United States Patent and Trademark Office

· · · · · · · · · · · · · · · · · · ·		
APPLICATION NO.	FILING DATE	FIRST NAMED INVENTOR	ATTORNEY DOCKET NO.	CONFIRMATION NO.
10/612,229	07/01/2003	James David Hensley	10008165-4	4871
7	590 09/08/2004		EXAM	INER
HEWLETT-PACKARD COMPANY			NGUYEN, KHIEM D	
Intellectual Pro	perty Administration			
P.O. Box 272400			ART UNIT	PAPER NUMBER
Fort Collins, CO 80527-2400		2823

DETAILED ACTION

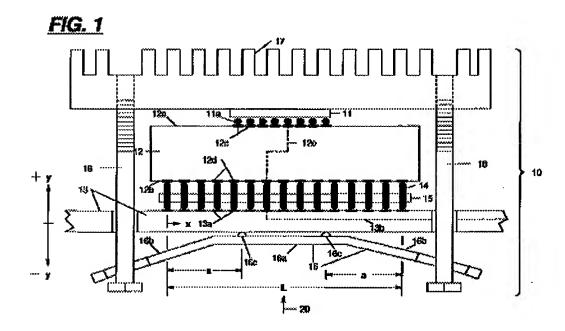
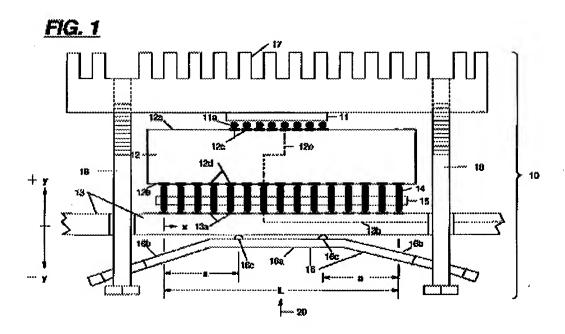
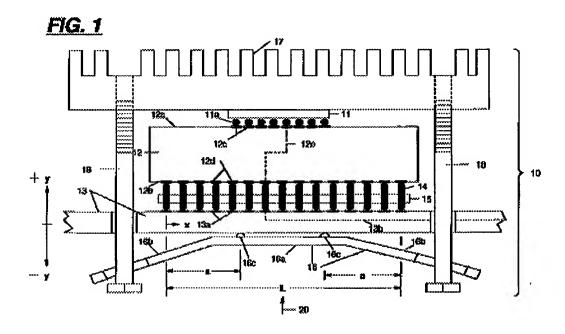
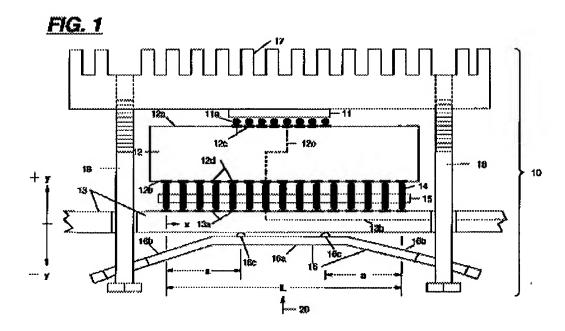
In re claim 1, <u>Tustaniwskyi</u> discloses a method to assemble a pre-curved bolster plate 16 to one side of a substrate 13 having a first side and a second side, comprising: attaching a component 15 to an electrical contact area 13a on said first side of the substrate 13; and attaching the pre-curved bolster plate 16 on the second side of the substrate 13, wherein the pre-curved bolster plate is attached to the second side opposite the electrical contact area on the first side of the substrate 13 (col. 3, line 2 to col. 4, line 4 and FIG. 1).

In re claim 5, <u>Tustaniwskyi</u> discloses wherein the pre-curved bolster plate 16 has a spherical curvature (FIG. 1).

In re claim 6, <u>Tustaniwskyi</u> discloses wherein the pre-curved bolster plate 16 has a cylindrical curvature (FIG. 1).

In re claim 21, <u>Tustaniwskyi</u> discloses a method for providing support substrate, the method comprising: attaching a component 115 to an electrical contact area 13a on a first side of the substrate 13; and attaching a pre-curved bolster plate 16 on a second side 16c of the substrate 13, the pre-curved bolster plate 16 having a pre-calculated radius of curvature prior to attachment to the second side 16c of the substrate 13 (col. 3, line 2 to col. 4, line 4 and FIG. 1).

In re claim 25, <u>Tustaniwskyi</u> discloses wherein the pre- curved bolster plate 16 has a spherical curvature (FIG. 1).

In re claim 26, <u>Tustaniwskyi</u> discloses wherein the pre-curved bolster plate has a cylindrical curvature (FIG. 1).

In re claim 37, <u>Tustaniwskyi</u> discloses a method for coupling a plate member to an electrical packaging assembly, the method comprising: providing an electrical packaging assembly (11, 15); disposing a plate member 16 against the electrical packaging assembly; flexing the plate member towards the electrical packaging assembly to produce a flexed plate member 16; and coupling the flexed plate member to the electrical packaging assembly (col. 3, line 2 to col. 4, line 4 and FIG. 1).

In re claim 39, <u>Tustaniwskyi</u> discloses wherein the flexing comprises flexing opposed ends of the plate member 16 towards a substrate 13 of the electrical packaging assembly (11, 15) until the plate member is generally flushed against the substrate 13 (FIG. 1).

In re claim 42, <u>Tustaniwskyi</u> discloses wherein the plate member 16 is stamped to achieve a spherical curvature (FIG. 1).
